Region 6 - Enforcement & Compliance Assurance Division

INSPECTION REPORT

Inspection Date(s):	02/13/2024 and 02/14/2024	
Media Program:	Drinking Water	
Regulatory Program(s)	Safe Drinking Water Act (SDWA)	
System Owner:	City of Sherman	
System Name:	City of Sherman Public Water System (PWS)	
System Physical Location:	243 La Cima Rd.	
(city, state, zip code)	Sherman, TX 75092	
Mailing address:	243 La Cima Rd.	
(city, state, zip code)	Sherman, TX 75092	
County/Parish:	Grayson County	
System Phone Number	(903) 892-7258	
System Contact:	Jim Cross	Water Systems Manager
	jimcross@cityofsherman.com	
FRS Number:	110013273698	
System Classification:	Community Water System (CWS)	
PWS ID:	TX0910006	
Media Identifier Number:	N/A	
NAICS:	N/A	
SIC:	4941	
Personnel participating in inspection:		
Sami Doupnik	EPA Region 6	Enforcement Officer
Fatima Shaikh	EPA Region 6	Enforcement Officer
Craig Young	EPA Region 6	Enforcement Officer
Daniel Kim	EPA Region 6	Enforcement Officer
Danny O'Connell	PG Environmental/ERG (EPA Contractor)	Inspector

Photograph 1. 2/13/2024 12:53 PM DSCN9214.JPG

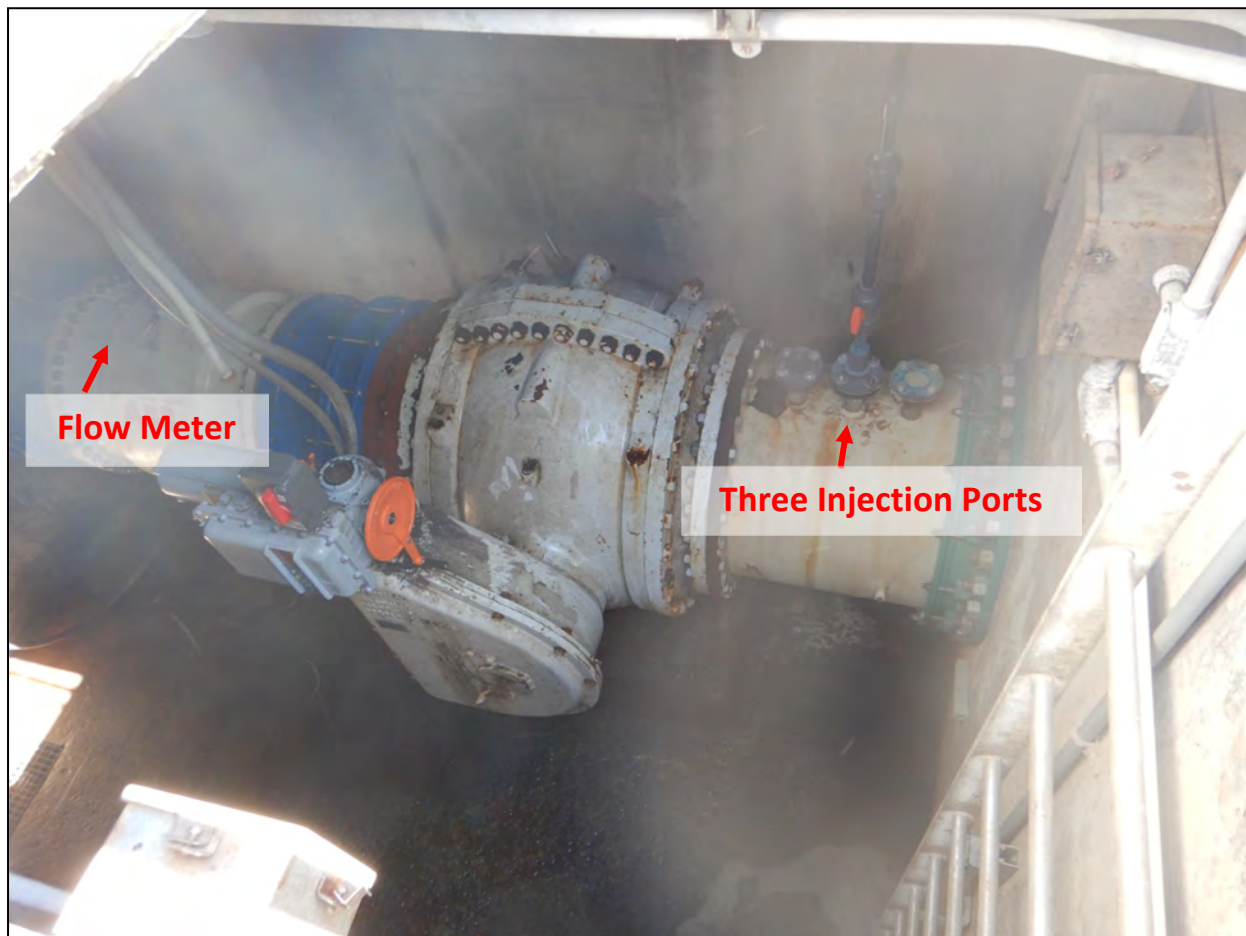
Conventional Plant, Raw Water Meter Vault View of the raw water influent line inside the raw water meter vault. There were three injection ports present on the line but only one had a chemical line attached to it (copper sulfate). The other two injection lines had been disconnected. The injection ports were downstream of the flow meter.

Photograph 18. 2/13/2024 3:25 PM IMG_0095.JPG

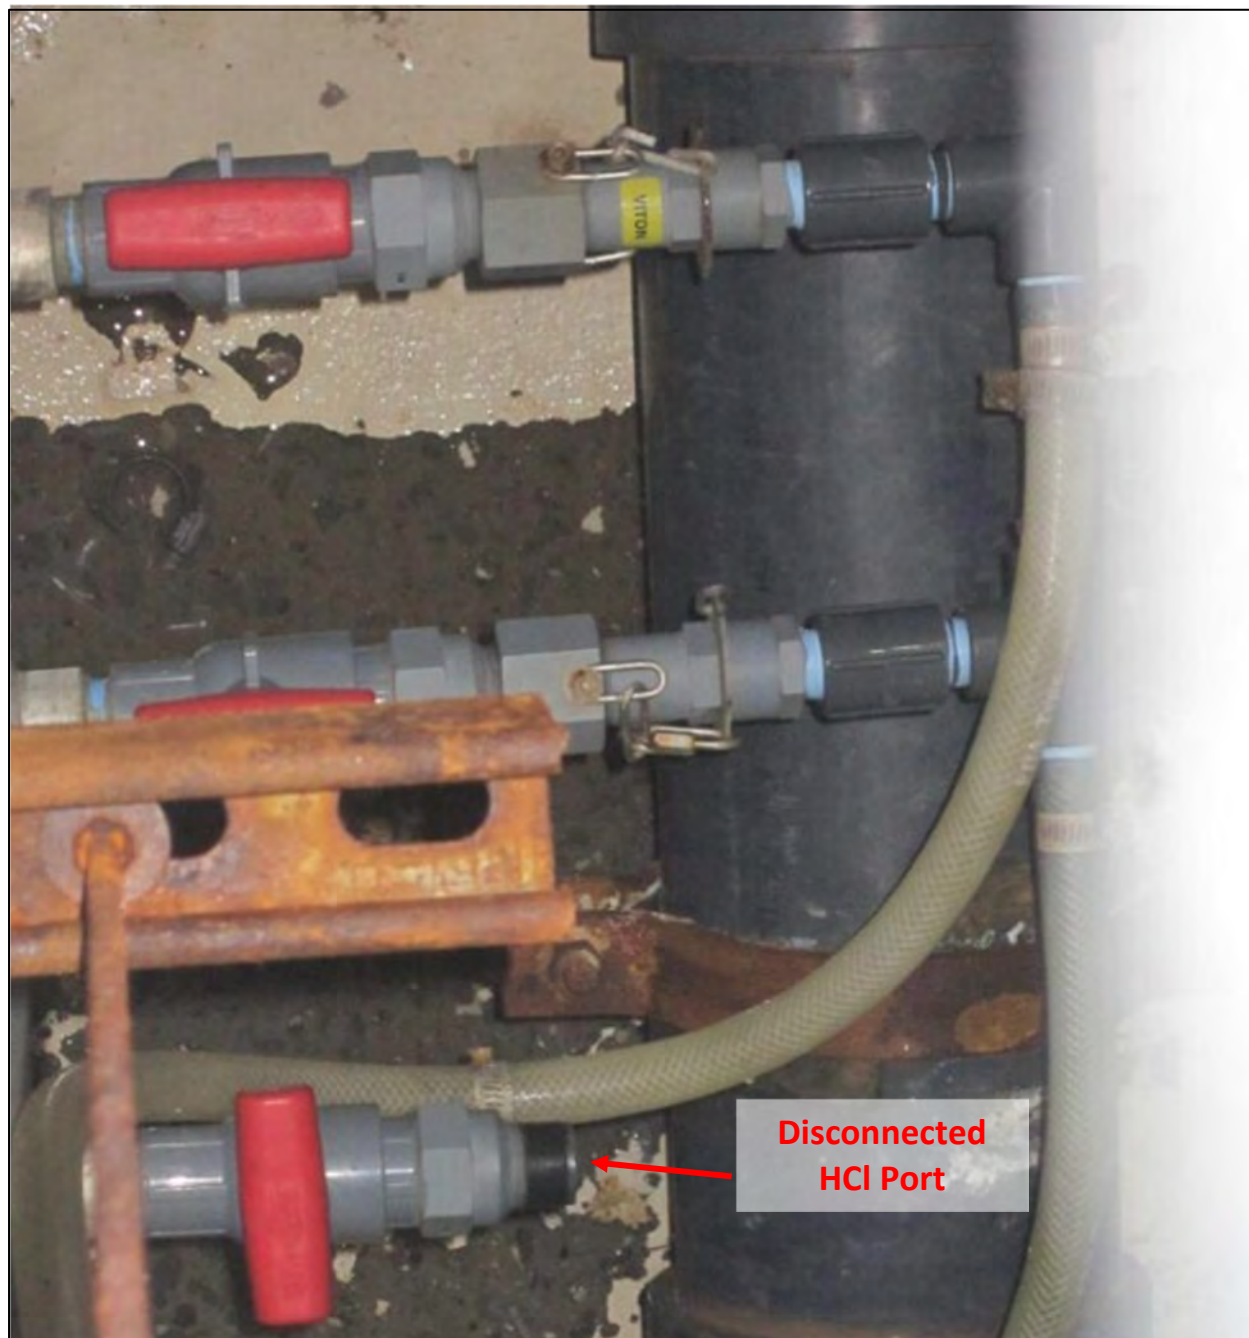
Membrane (UF/RO) Plant, RO Supply Line Additional view of the three unlabeled chemical injection ports and the disconnected HCl line.

Photograph 20. 2/13/2024 3:47 PM DSCN9347.JPG

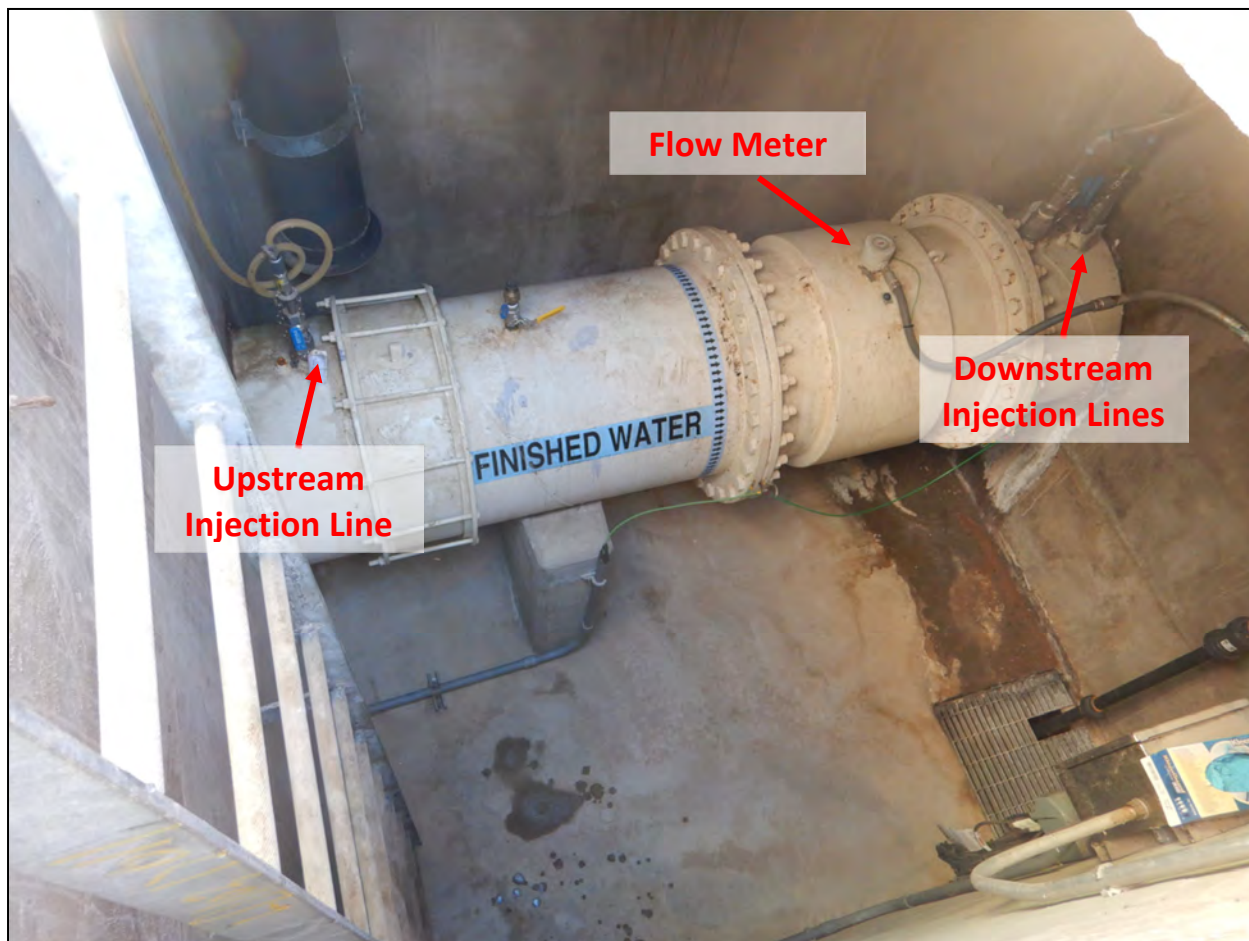
Clearwell Meter Vault View inside the clearwell meter vault where produced water flows from the UF/RO plant into the North and South clearwells. There were three unlabeled chemical lines attached to the water line, one upstream of the flow meter and two downstream of the flow meter. Caustic, fluoride, and phosphate are injected into this line, but system representatives were unsure which chemical line injected which chemical.

Photograph 41. 2/14/2024 11:19 AM IMG_0044.JPG

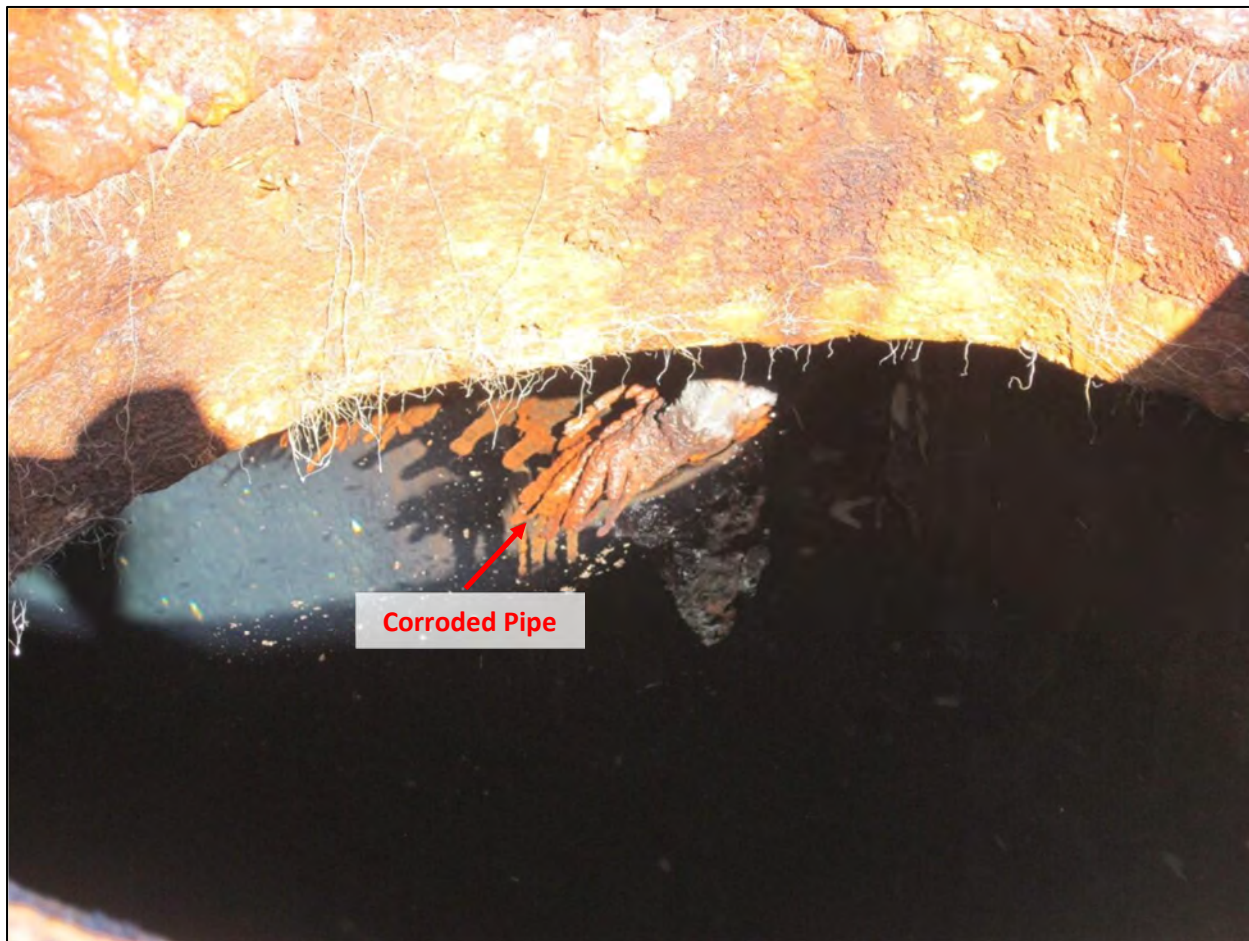
Fairview Tank View of a heavily corroded metal pipe inside of the Fairview Tank that was visible from inside one the manholes. Operators indicated that the metal pipe was the end of an old line that extended from a small surge tank that used to be fed by a groundwater well that was no longer present at the site. The pipe did not appear to be plugged, leaving an open pipe into the tank.

Photograph 42. 2/14/2024 11:19 AM IMG_0043.JPG

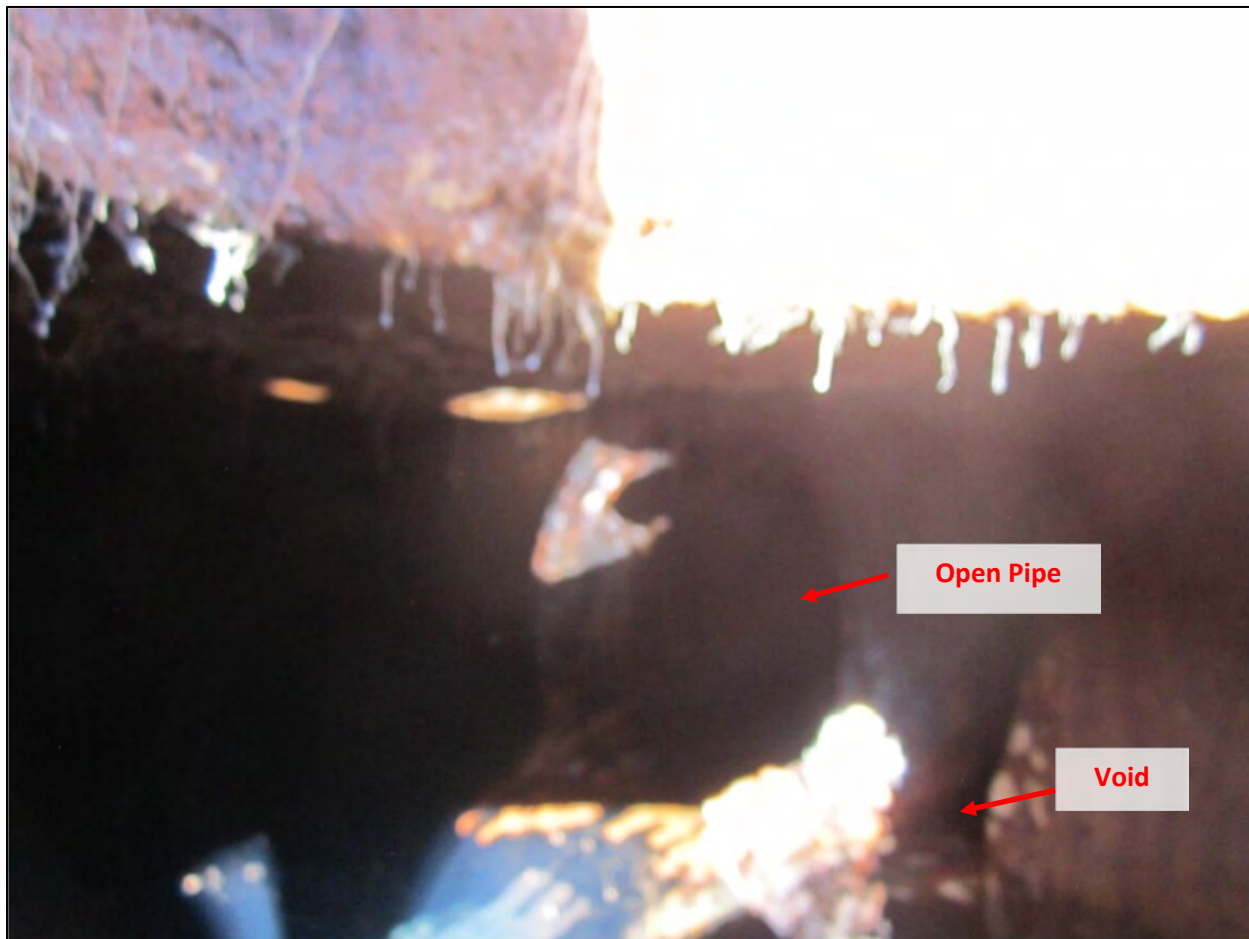
Fairview Tank View of a void in the tank wall next to the corroded metal pipe. It was unclear if the void was a wall failure or situation where the historic pipe settled, creating the void. The void provided direct access to the finished water supply.

Photograph 49. 2/14/2024 1:32 PM IMG_0079.JPG

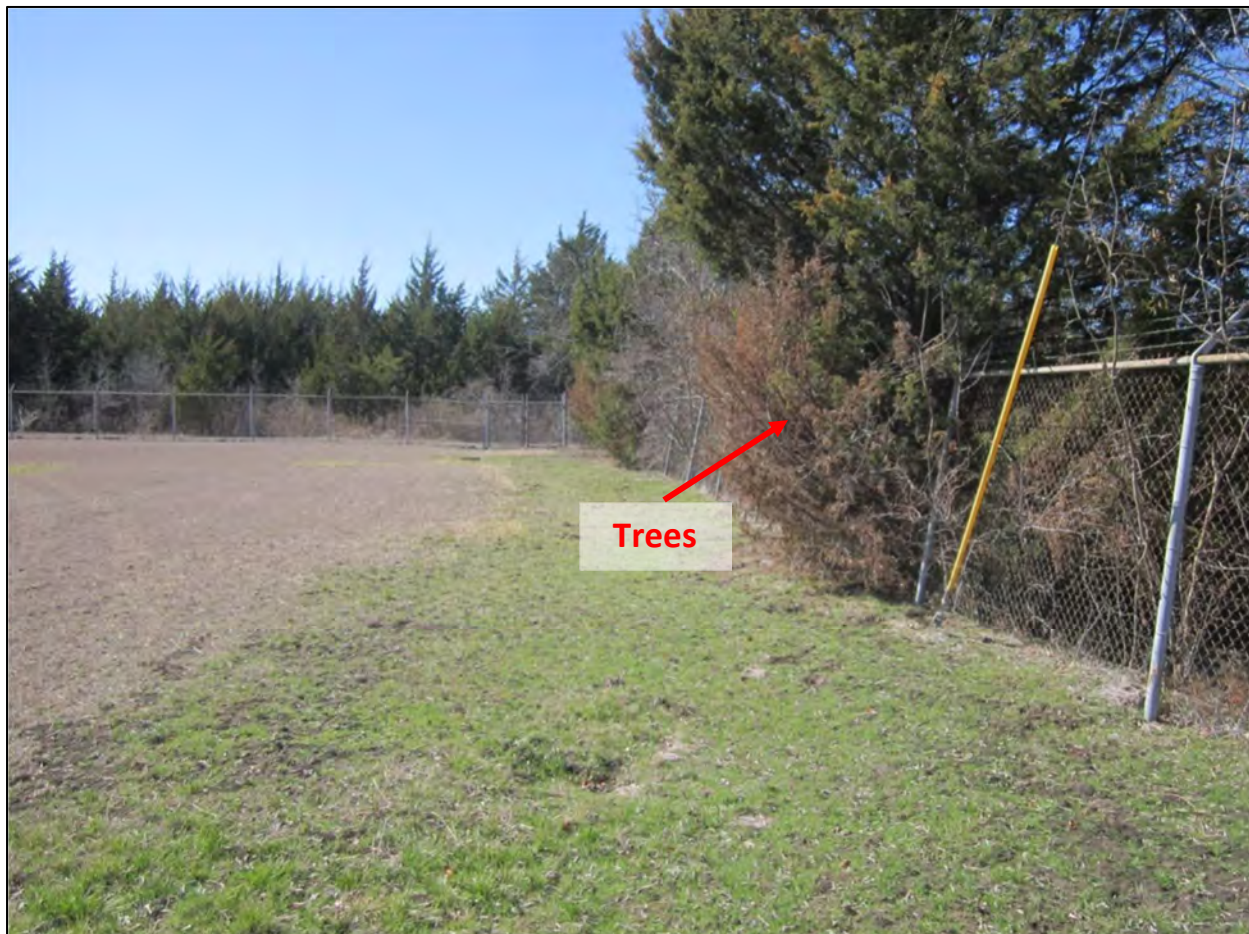
Stephens Site, Perimeter Fence View of the perimeter fence surrounding the Stephens site. There were multiple trees growing through and around the fence, potentially compromising the integrity of the fence and security of the site.

Photograph 53. 2/14/2024 1:50 PM DSCN9515.JPG

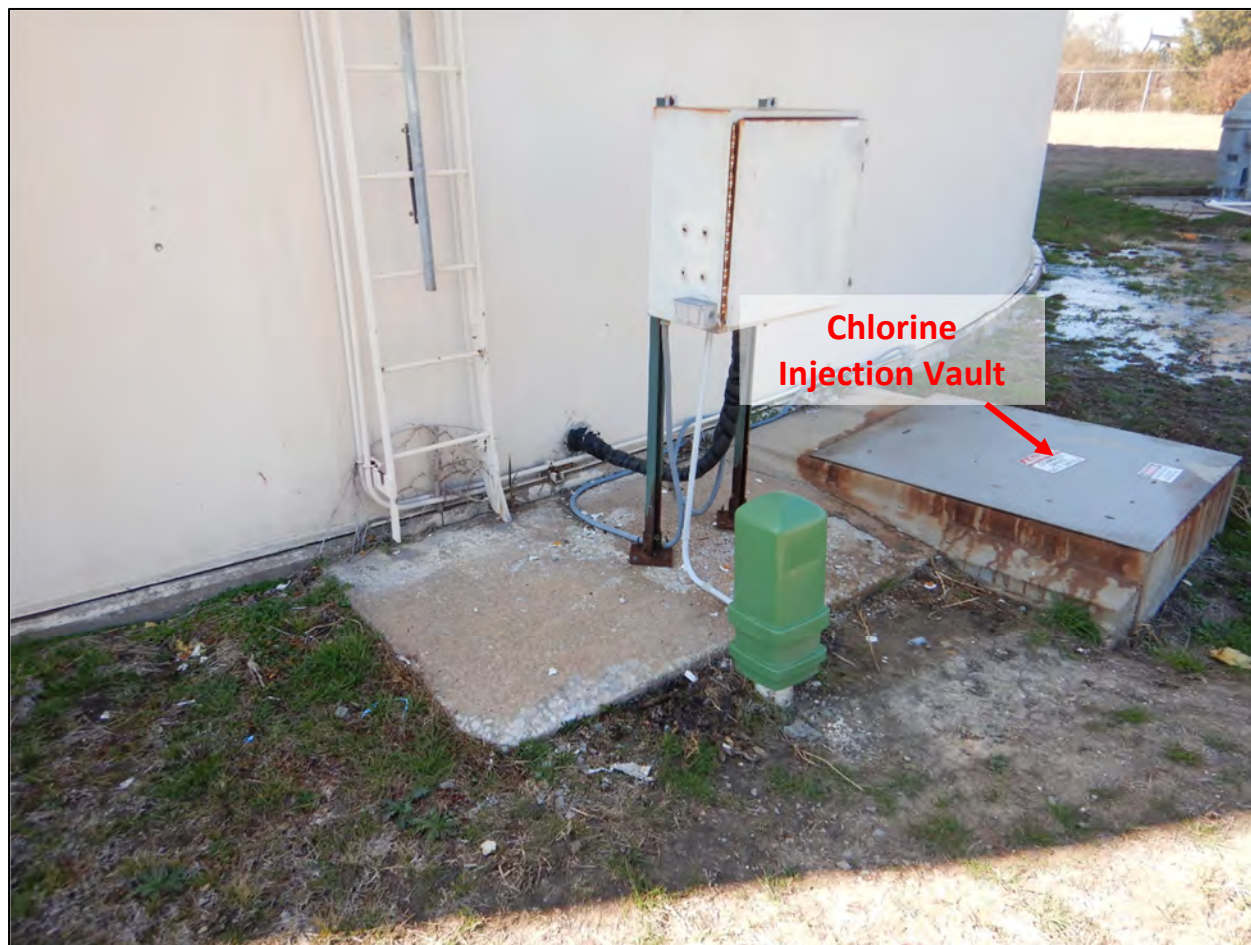
Stephens Tank View of the access ladder for the Stephens Tank. The ladder lacked a ladder shield and extended to the ground. . The chlorine injection vault was flooded.

Stephens Pump Station – Ground Storage Tank L

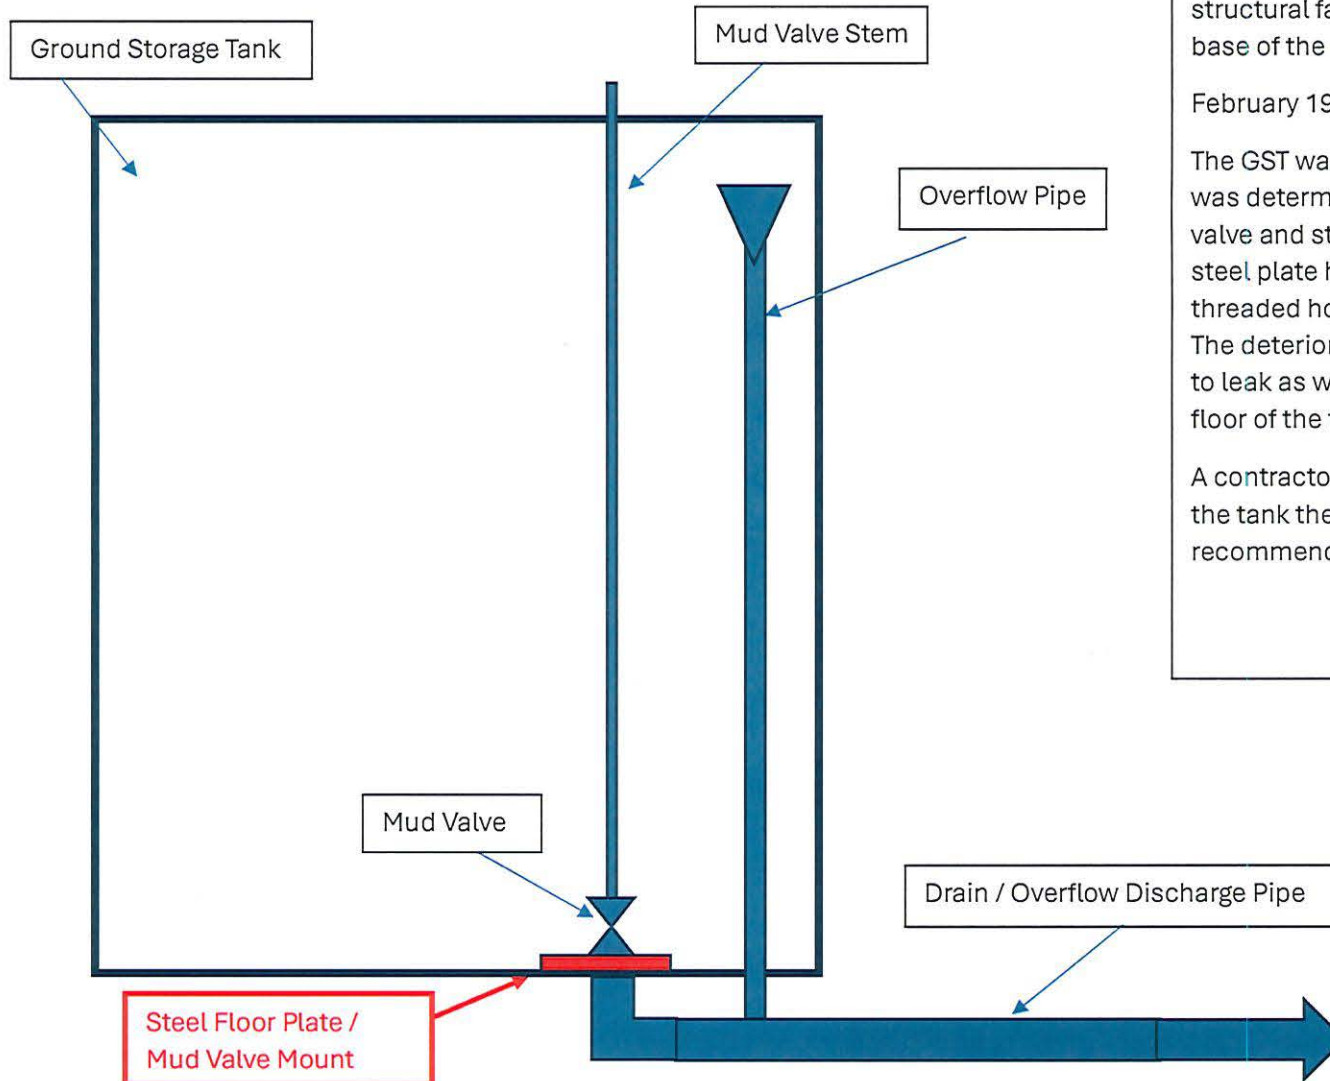
Stephens Pump Station GST experienced a structural failure and water was leaking at the base of the tank.

A contractor has been scheduled to inspect the tank the week of 3/4/24 and provide recommendations for the repair.

Stephens GW Pump Station Security Improvement – Fence Relocation

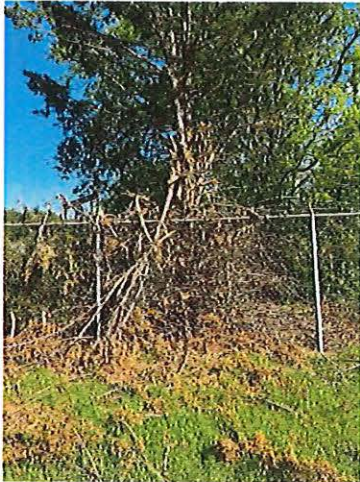
Action: The security fence ended at the building allowing access without entering the fence. Additional fencing was added to extend the fenced area and prevent access to the building without entering the fenced area

After
